ADDITIONAL INFO WITH
RESPONSE TO QUESTIONS CONCERNING THEIR
ANALYSIS OF THE TMI-1 REACTOR BUILDING
SPRAY SYSTEM.....2 PG
18 ENCL

Three Mile Island Nuclear Station Unit 1 (TMI-1)
Operating License No. DPR-50
Docket No. 50-289

By letters dated October 13 and November 12, 1975, Metropolitan Edison Company transmitted the results of our analysis of the TMI-1 Reactor Building Spray System. Your letter dated January 20, 1976 requested additional information be provided to permit completion of your review on this subject. The specific information requested and our response are contained below. *

Figure Va
Metropolitan Edison Company
Three Mile Island Nuclear Station Unit 1
Comparison of Analytical Results to Half Flow Water Test
Borated Water Storage Tank Drawdown

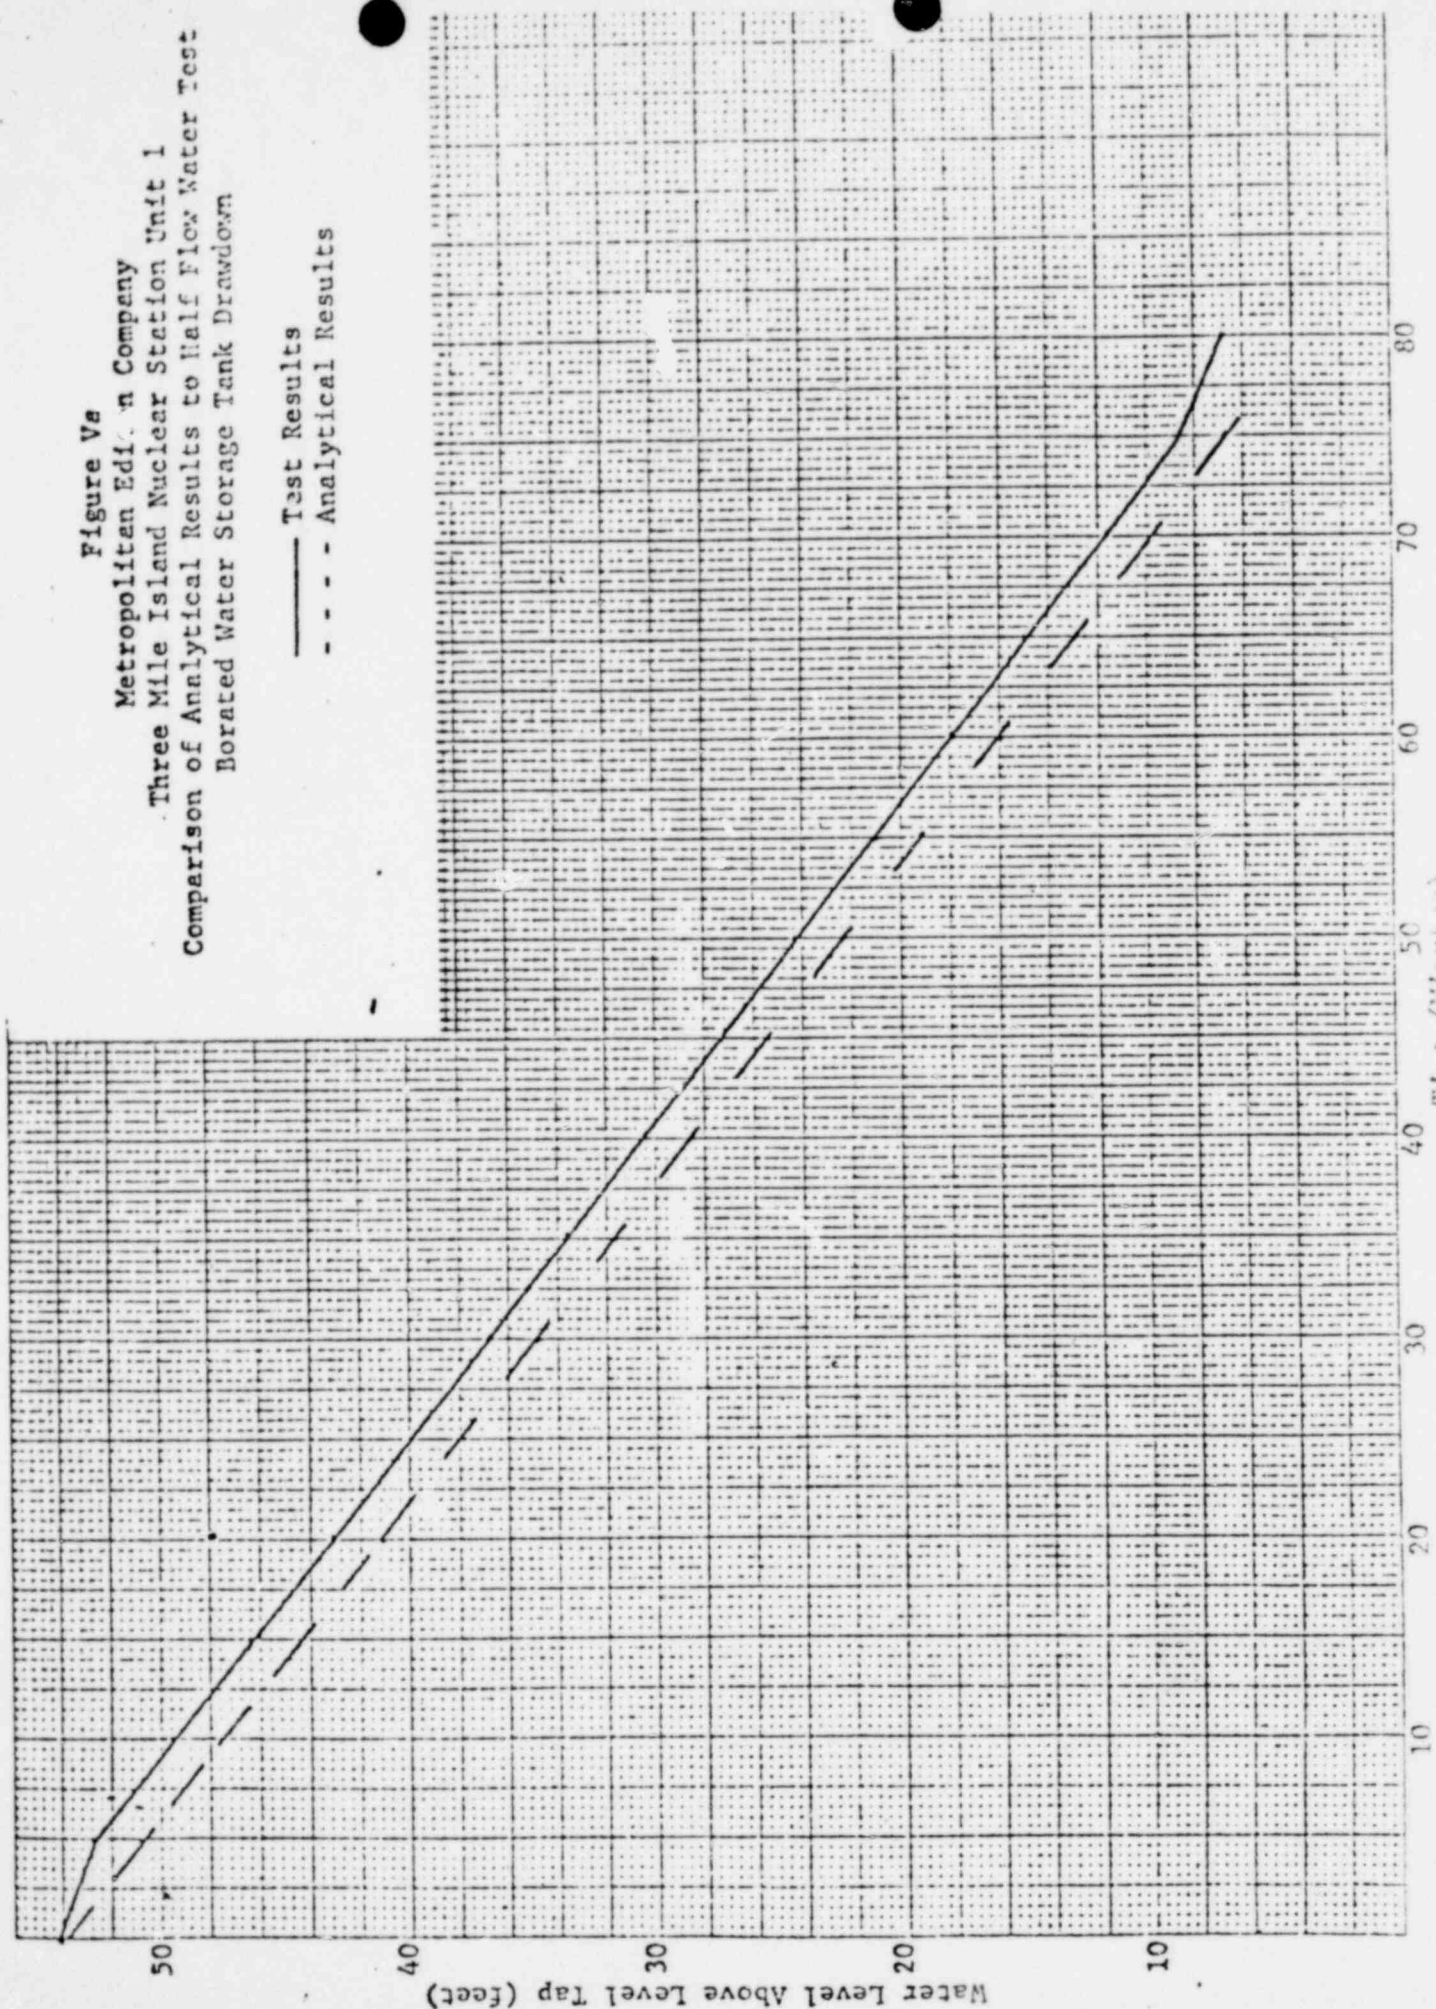
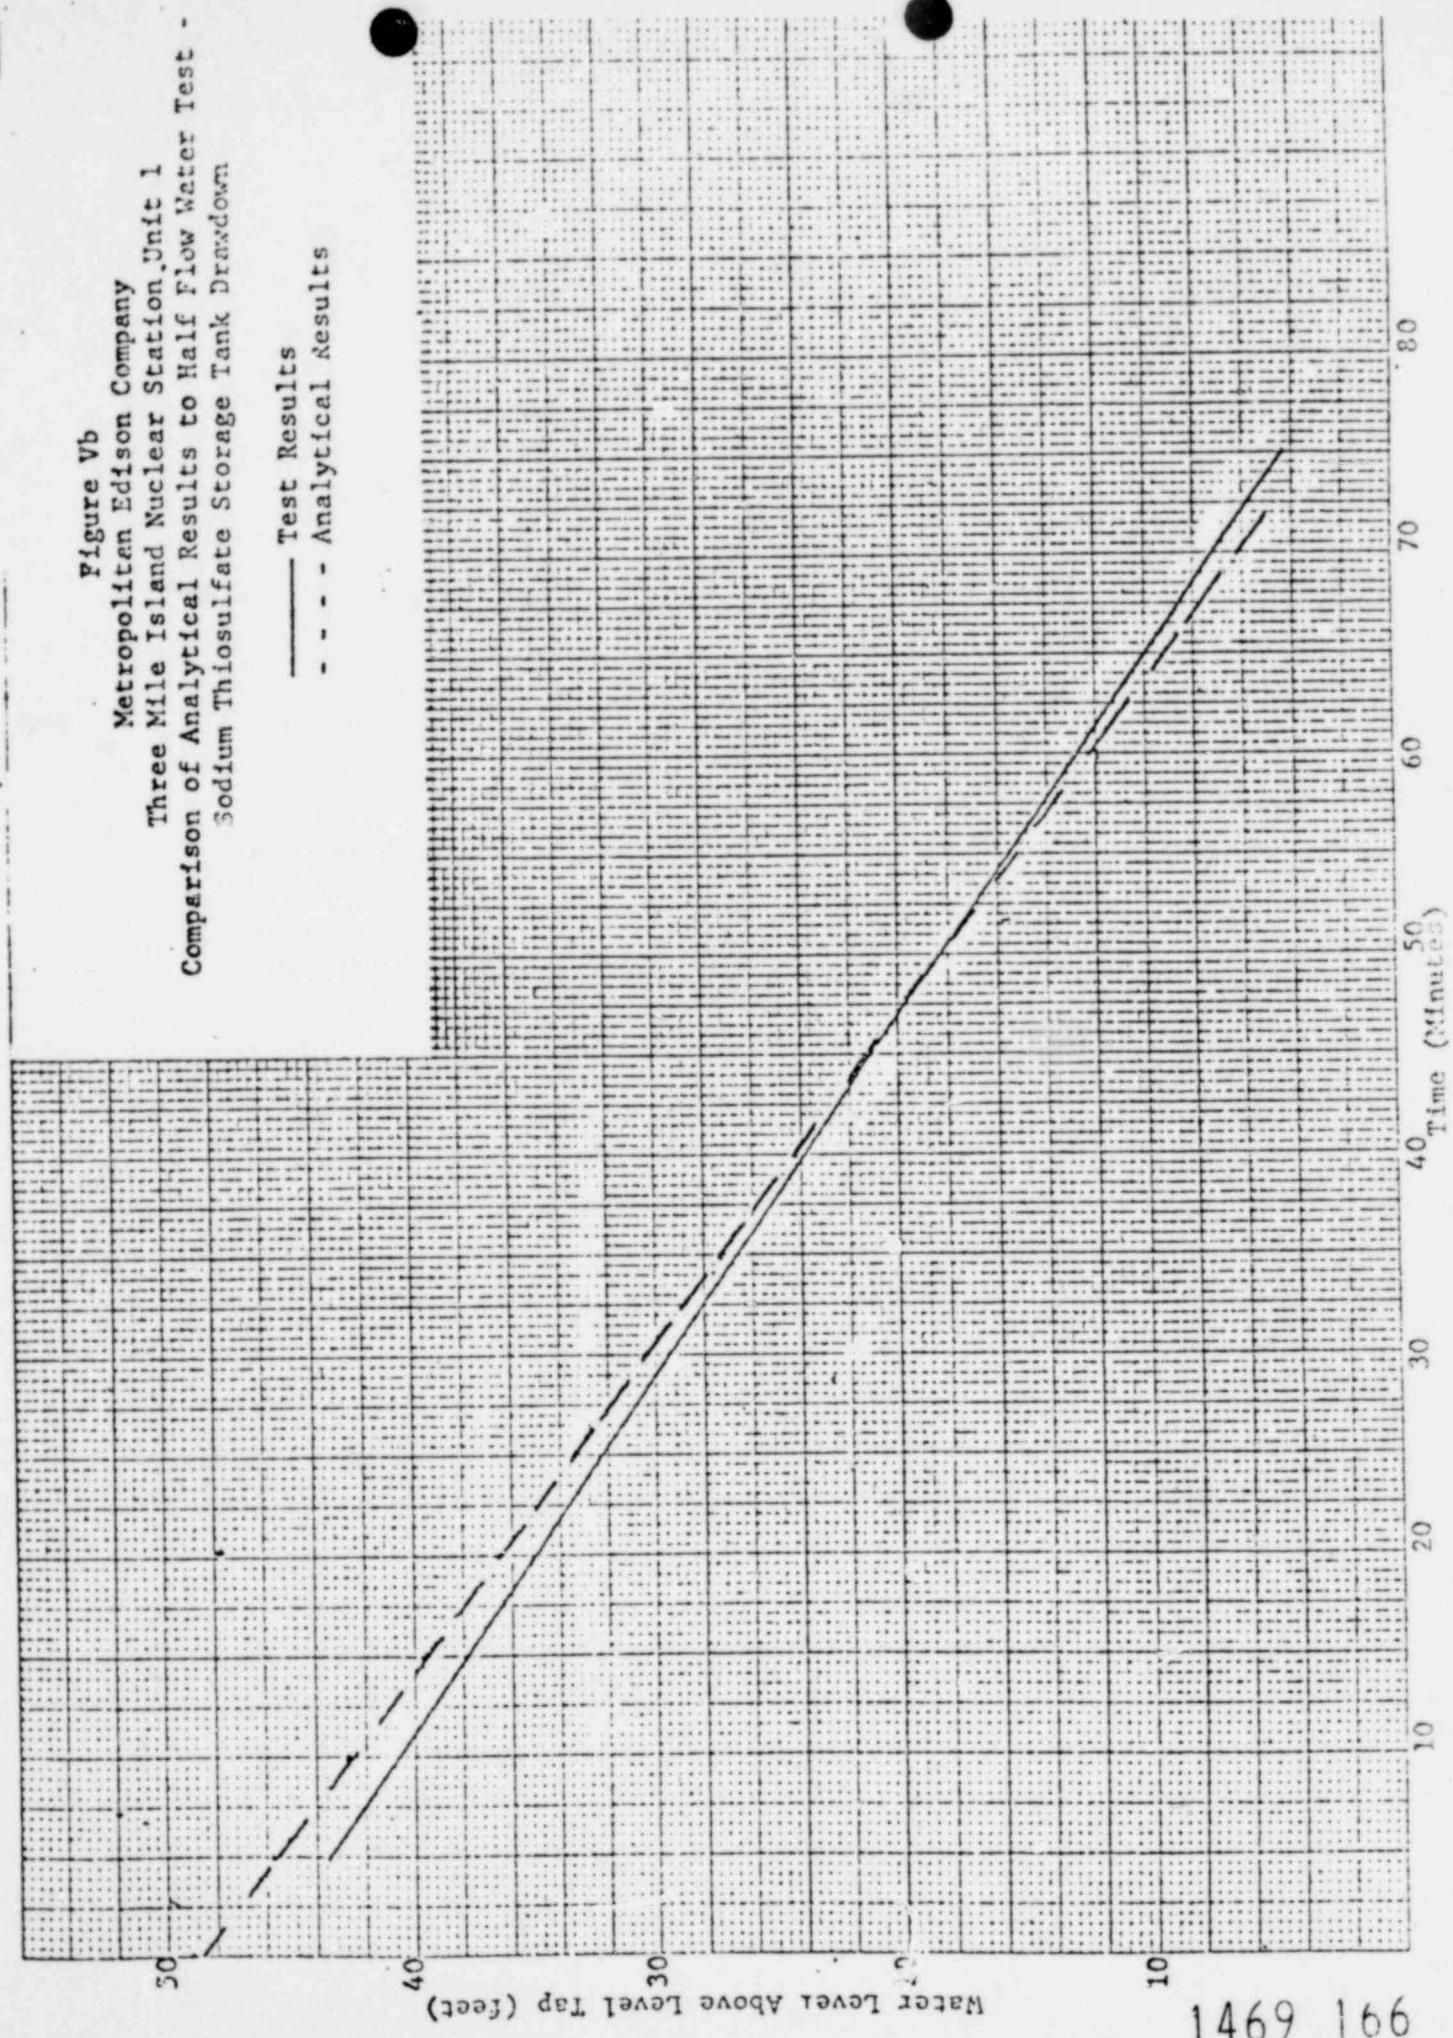
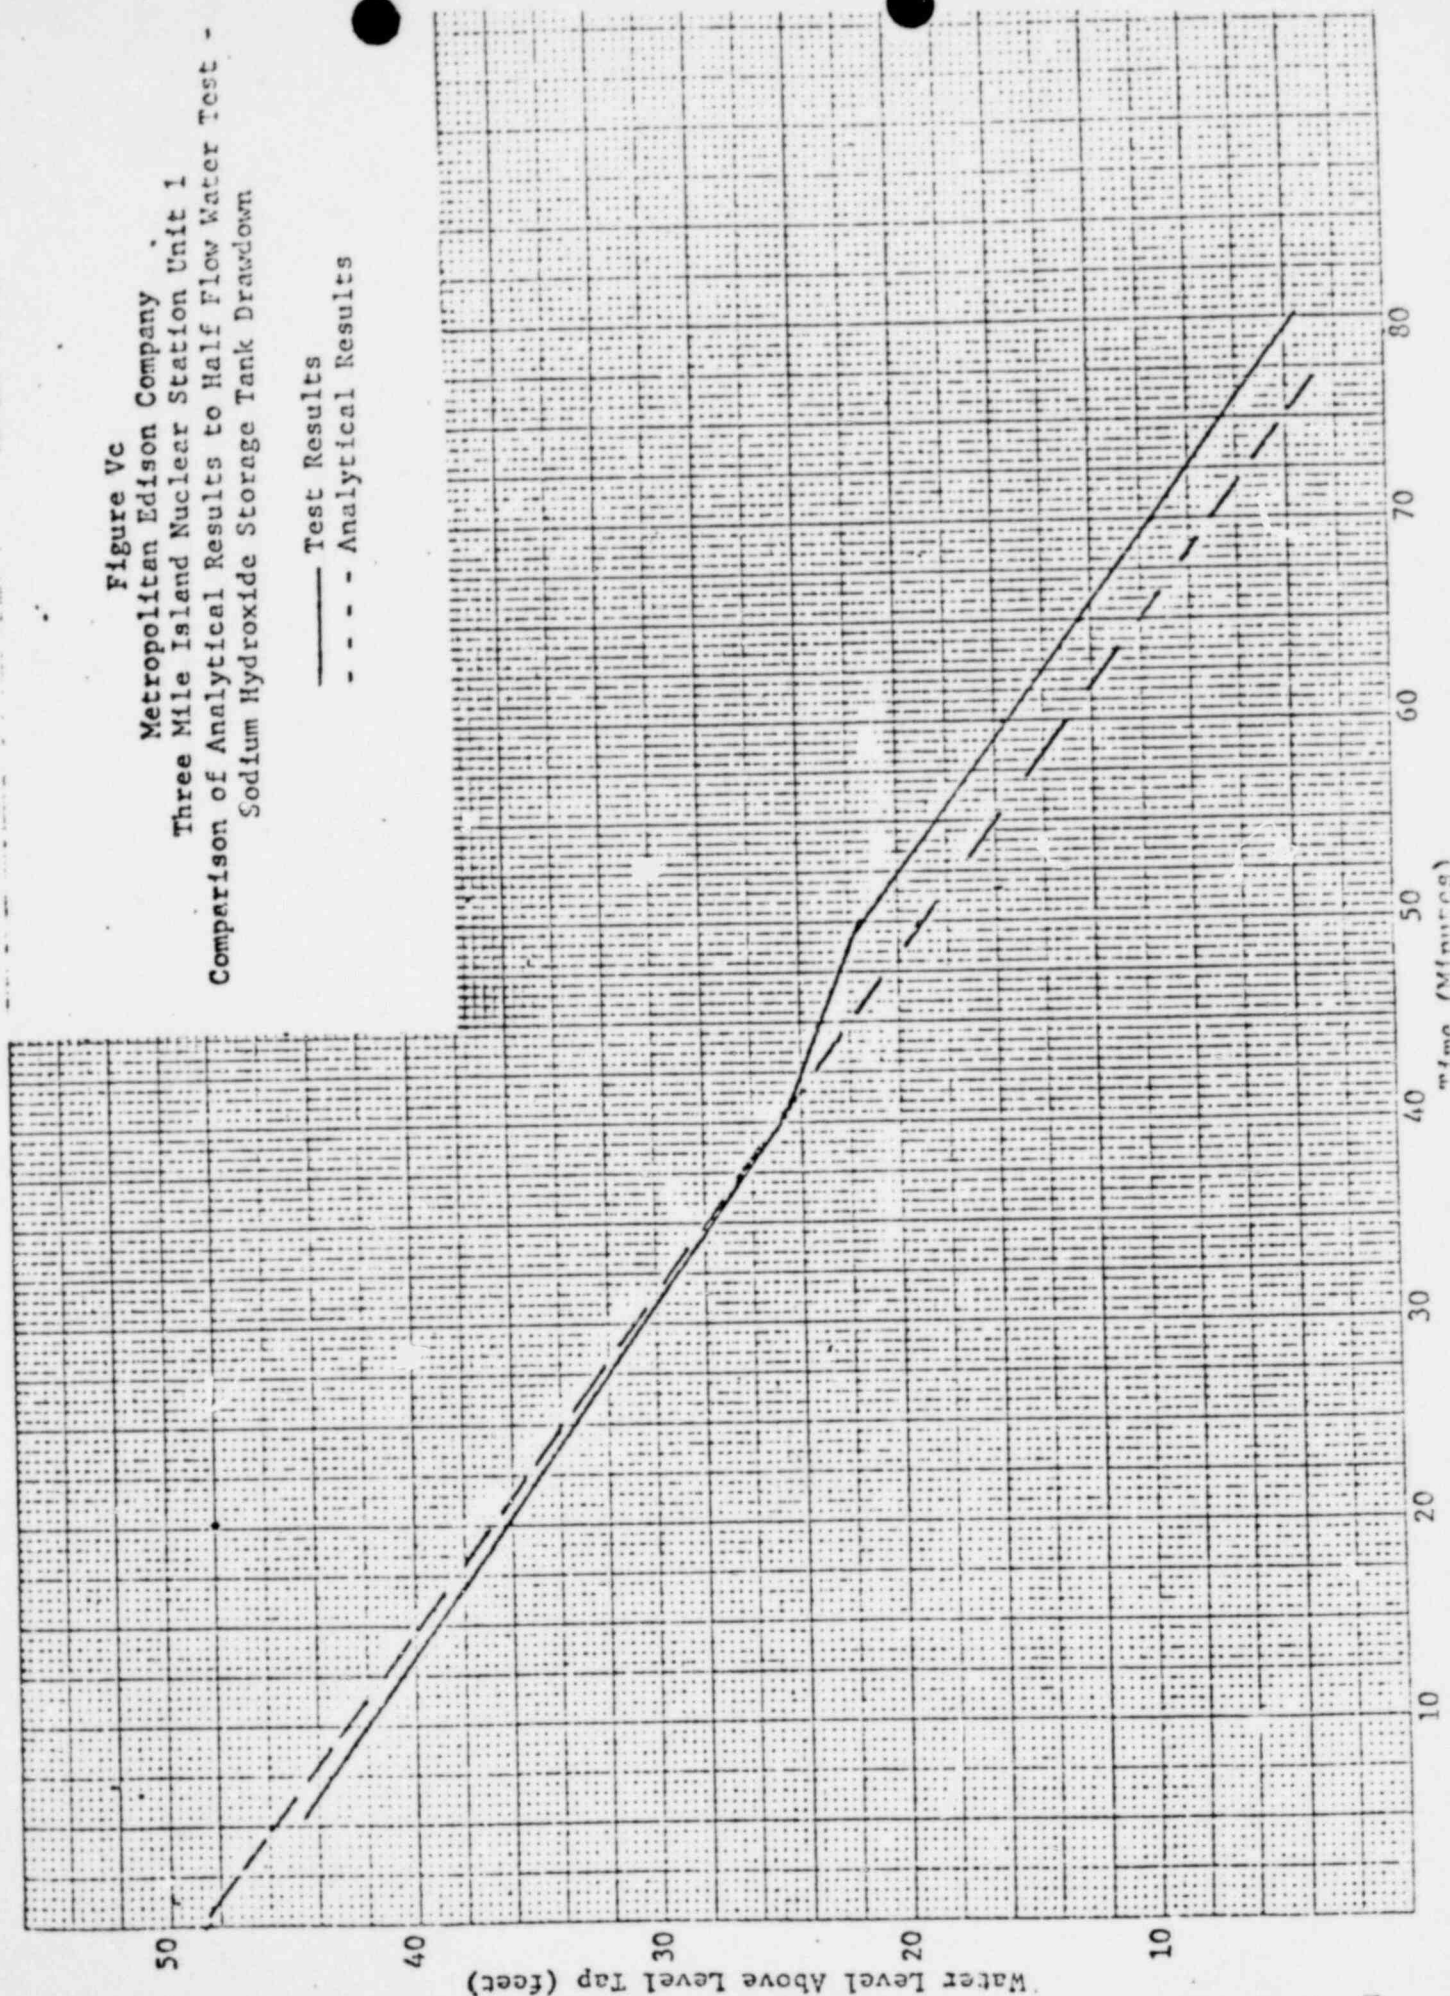
2. Describe and justify the methods used for determining the static pressure head due to the liquid in the BWST, the aspiration force in the spray lines at the chemical tank discharge points, and the friction forces involved.

Further verification of the program is provided by comparison to the half flow water test in which pumps DH-PlB and BS-PlB did not operate. (Figure III). In contrast to the full flow test, the flow rates through the pumps were not constant. This effect was included in the analysis. Good agreement between the observed and calculated results is shown in Table II and Figures V a, b, c.
